PCI-SIG ENGINEERING CHANGE NOTICE

TITLE:	Downstream Port Containment (DPC)
DATE:	Introduced: Aug 11, 2011; Last Updated: Feb 2, 2012 Final Approval by PWG: Feb 9, 2012
AFFECTED DOCUMENT:	PCI Express Base Specification Revision 3.0
SPONSORS:	Peter Onufryk, IDT; Joe Cowan, HP; Michael Krause, HP

Figure 6-2: Flowchart Showing Sequence of Device Error Signaling and Logging Operations

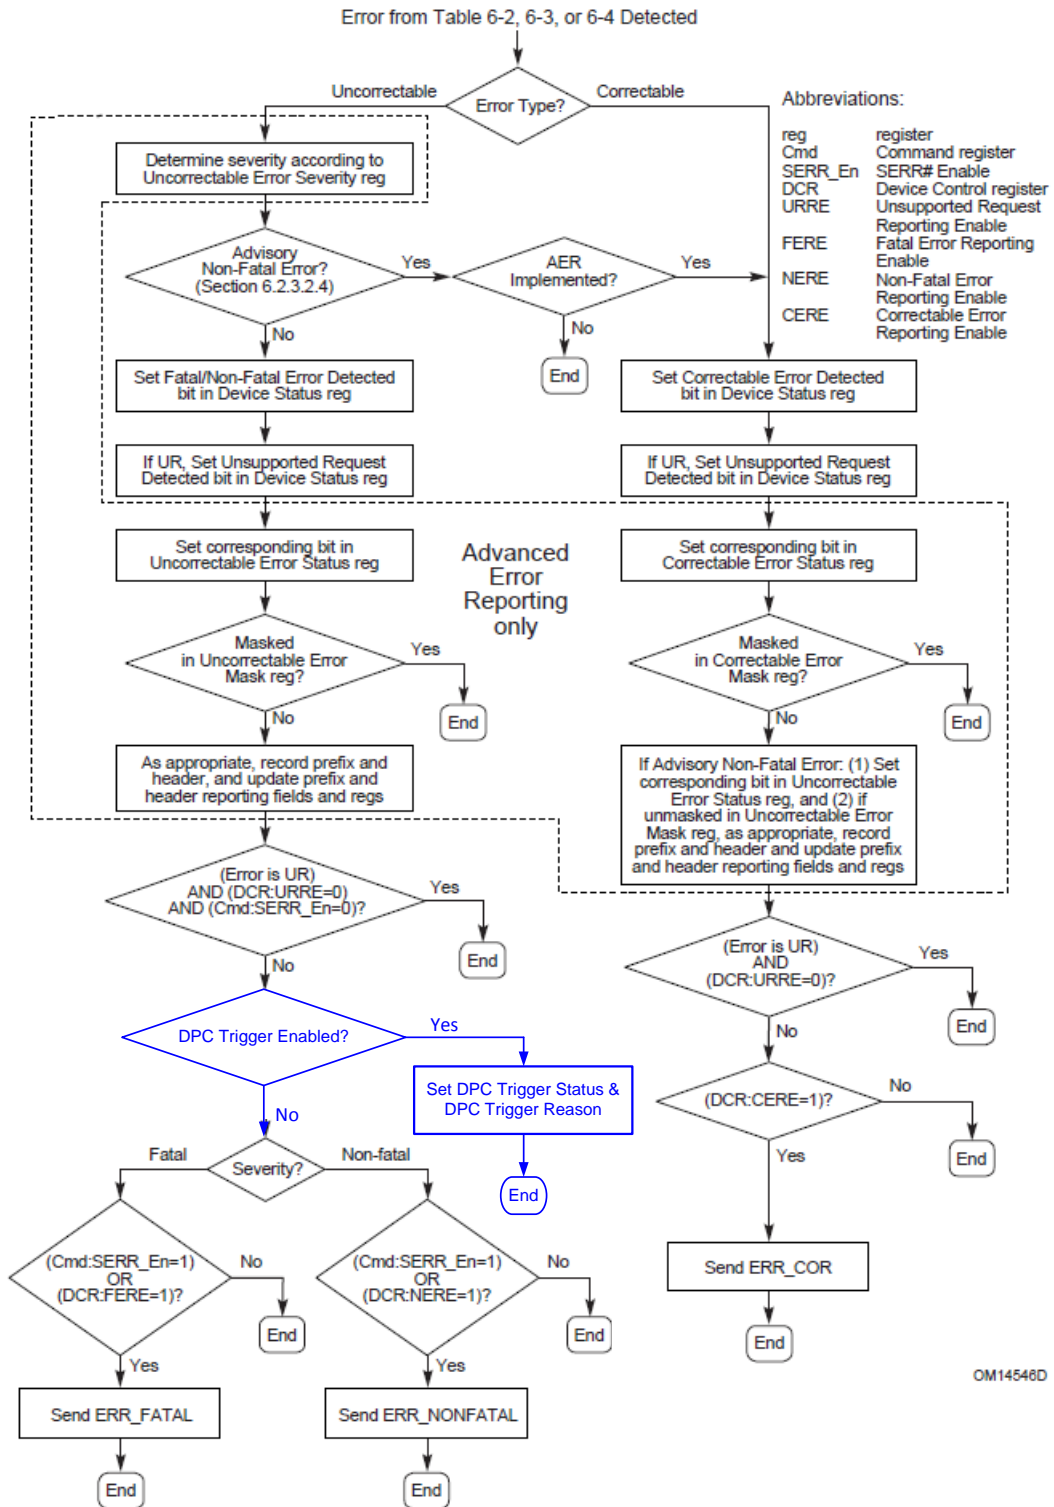
Modify Figure 6-2 as follows:

Modify Figure 7-20 as follows:

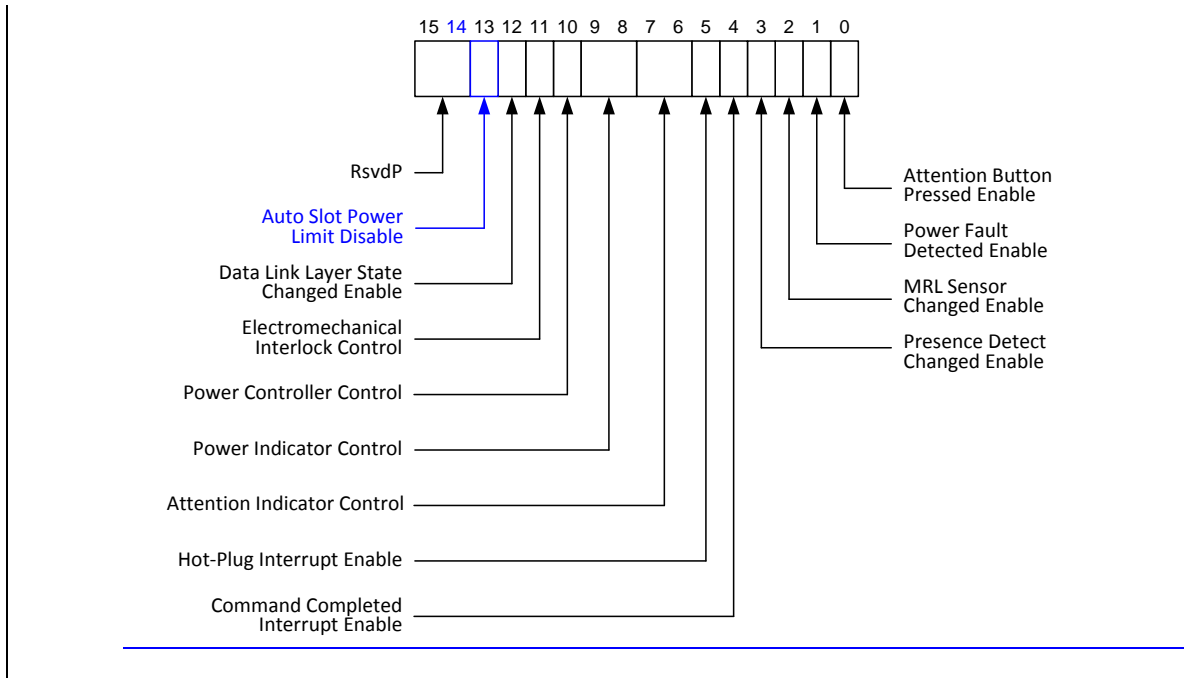
Add the following row to Table 7-20:

<u>13</u>	<p>Auto Slot Power Limit Disable – When Set, this disables the automatic sending of a Set_Slot_Power_Limit Message when a Link transitions from a non-DL_Up status to a DL_Up status.</p> <p><u>Default value of this bit is implementation specific.</u></p>	<u>RW</u>
-----------	--	-----------

Modify Figure 7-39 as follows:

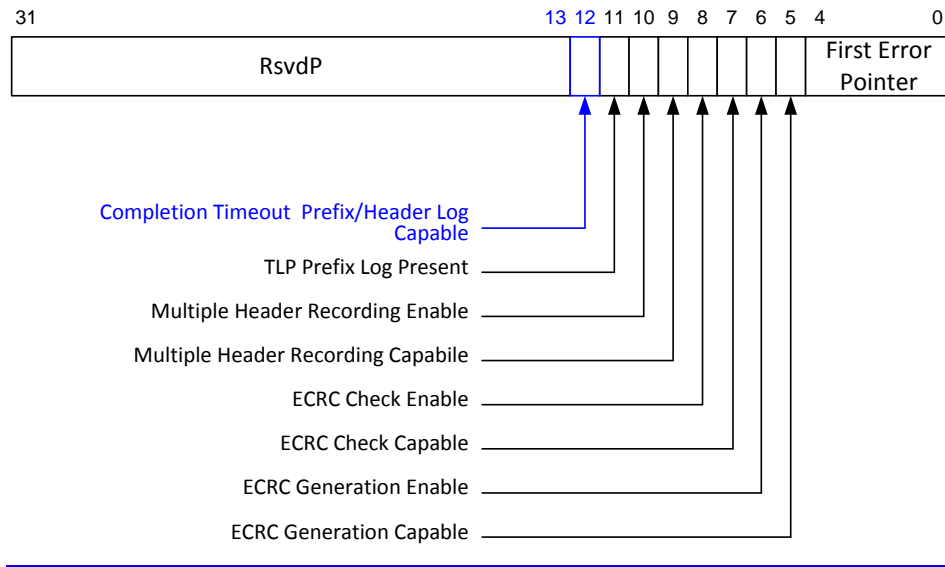
Add the following rows to Table 7-36:

<u>12</u>	<p><u>Completion Timeout Prefix/Header Log Capable</u> – If Set, this bit indicates that the Function records the prefix/header of Request TLPs that experience a <u>Completion Timeout error</u>.</p>	<u>RO</u>
-----------	--	-----------
